Access Compliance Report

Public Rights-of-Way

(Curb Ramps)

Intersection ID: 48857	Main Street: FENCELINE_DR	Cross Street: GREENFINCH_DR	Location: SE
ADA ID: B965323C1276	Ramp Type: PerpDiag	Initial Pass/Fail: Fail	Overall Compliance: No
Codes/Mitigation Info/Possible Solution		Field Measurements/Component Compliance	
Severity Score: 33.75

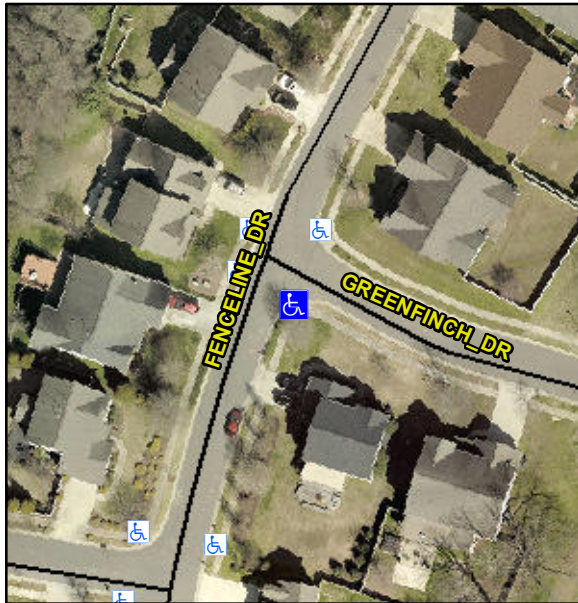
Not Found, R304.5.1, R304.2.2, R304.5.3

Compliance	Description	Data	Compliance	Description	Data
N/A	Ramp Length (in)	52.0	No	Ramp Slope (%)	11.6
No	Ramp Width (in)	45.0	No	Ramp XSlope (%)	5.2
N/A	Flare Type LT	N/A	N/A	Flare Type RT	N/A
N/A	Flare Slope LT (%)	N/A	N/A	Flare Slope RT (%)	N/A
N/A	Flare Traversable LT?	N/A	N/A	Flare Traversable RT?	N/A
N/A	Landing Length (in)	N/A	N/A	DWS Provided?	N/A
N/A	Landing Width (in)	N/A	N/A	DWS Contrast?	N/A
N/A	Landing Slope (%)	N/A	N/A	DWS Length (in)	N/A
N/A	Landing X Slope (%)	N/A	N/A	DWS Full Width?	N/A
N/A	Landing Curb? (Y/N)	N/A	N/A	DWS Offset (in)	N/A
N/A	Shared Landing?	N/A			
N/A	Gutter Ponding?	N/A	N/A	Gutter Slope (%)	N/A
N/A	Gutter Lip Ht (in)	N/A	N/A	Gutter X Slope (%)	N/A
N/A	Painted X Walk1?	No	N/A	Painted X Walk2?	No
	X Walk 1 Direction	To NE		X Walk 2 Direction	To NW
N/A	X Walk 1 Width (in)	N/A	N/A	X Walk 2 Width (in)	N/A
	X Walk 1 Slope (%)	0.5		X Walk 2 Slope (%)	3.2
	X Walk 1 X Slope (%)	1.5		X Walk 2 X Slope (%)	0.0

Remove & Replace Curb Ramp With Two New Directional Ramps or Equivalent.
